Access Compliance Report

Public Rights-of-Way

(Curb Ramps)

Intersection ID: 5686	Main Street: STARMOUNT_AV	Cross Street: GREY_DOGWOOD_CT	Location: NW
ADA ID: 787798753473	Ramp Type: BlendTrans1	Initial Pass/Fail: Fail	Overall Compliance: No
Severity Score: 21.25			
Codes/Mitigation Info/Possible Solution		Field Measurements/Component Compliance

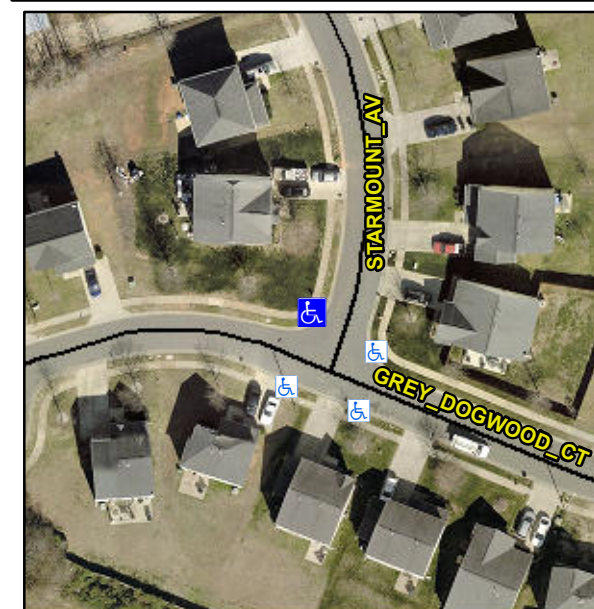
Not Found, R304.5.1, R304.5.3

Compliance	Description	Data	Compliance	Description	Data
N/A	Ramp Length (in)	47.0	Yes	BlendTrans Slope (%)	3.2
No	Ramp Width (in)	46.5	No	BlendTrans XSlope (%)	5.7
N/A	Flare Type LT	N/A	N/A	Flare Type RT	N/A
N/A	Flare Slope LT (%)	N/A	N/A	Flare Slope RT (%)	N/A
N/A	Flare Traversable LT?	N/A	N/A	Flare Traversable RT?	N/A
N/A	Landing Length (in)	N/A	N/A	DWS Provided?	N/A
N/A	Landing Width (in)	N/A	N/A	DWS Contrast?	N/A
N/A	Landing Slope (%)	N/A	N/A	DWS Length (in)	N/A
N/A	Landing X Slope (%)	N/A	N/A	DWS Full Width?	N/A
N/A	Landing Curb? (Y/N)	N/A	N/A	DWS Offset (in)	N/A
N/A	Shared Landing?	N/A			
N/A	Gutter Ponding?	N/A	N/A	Gutter Slope (%)	N/A
N/A	Gutter Lip Ht (in)	N/A	N/A	Gutter X Slope (%)	N/A
N/A	Painted X Walk1?	No	N/A	Painted X Walk2?	No
	X Walk 1 Direction	To SW		X Walk 2 Direction	To SE
	X Walk 1 Width (in)	N/A		X Walk 2 Width (in)	N/A
	X Walk 1 Slope (%)	4.5		X Walk 2 Slope (%)	2.0
	X Walk 1 X Slope (%)	1.0		X Walk 2 X Slope (%)	4.8

N/A	Ramp inside XWalk1?	N/A	N/A	Ramp inside XWalk2?	N/A
	Road Slope (%)	4.3		Clear Space?	N/A
	Road X Slope (%)	3.7	N/A	Clear Space to XWalk (in)	N/A
N/A	Any Obstructions?	N/A	N/A	Storm Grate/Utility Hazard?	N/A
	Obstruction Type			Storm Grate/Utility Type	
		N/A			N/A
			Yes	Surface Condition? (G/P)	Good
			No	Curb Slope (%)	9.1

Remove & Replace Curb Ramp With Two New Directional Ramps or Equivalent.
